## Product / Process Change Notification (PCN)

**PCN #:** PCN\_IndHCM\_20191104

**Affected Series:** WE-HCM; 74430820xxx

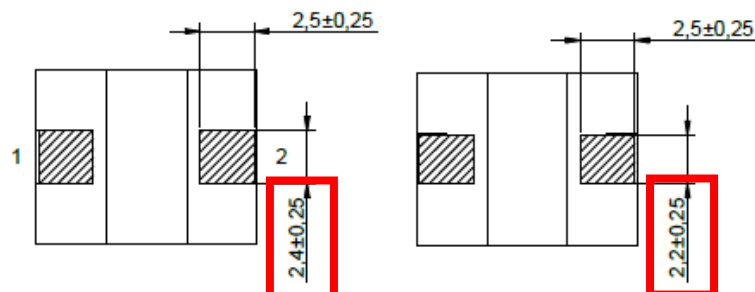
In the product drawing the dimension of the width of the clip will change:

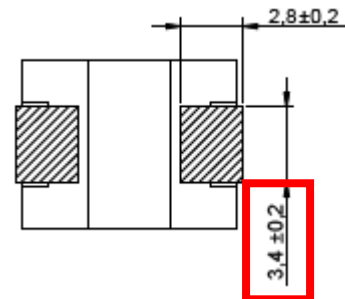
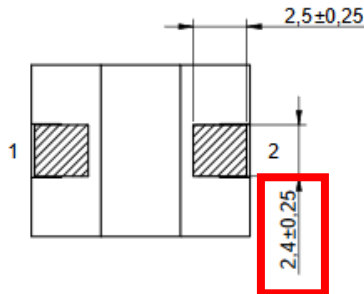
Following parts are affected:

Before change

After change

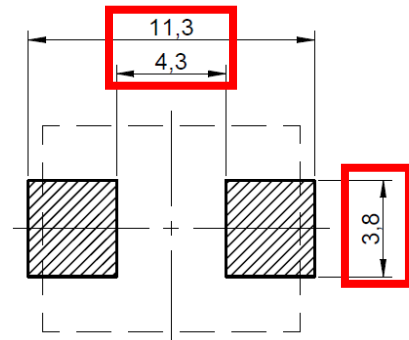
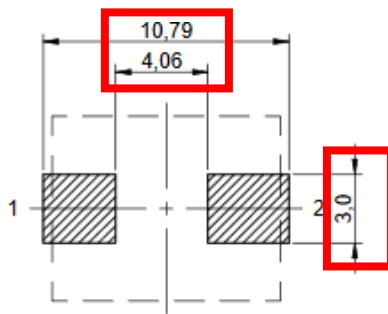
Also the dimension of the Recommended Land Pattern will change:

Before change

After change
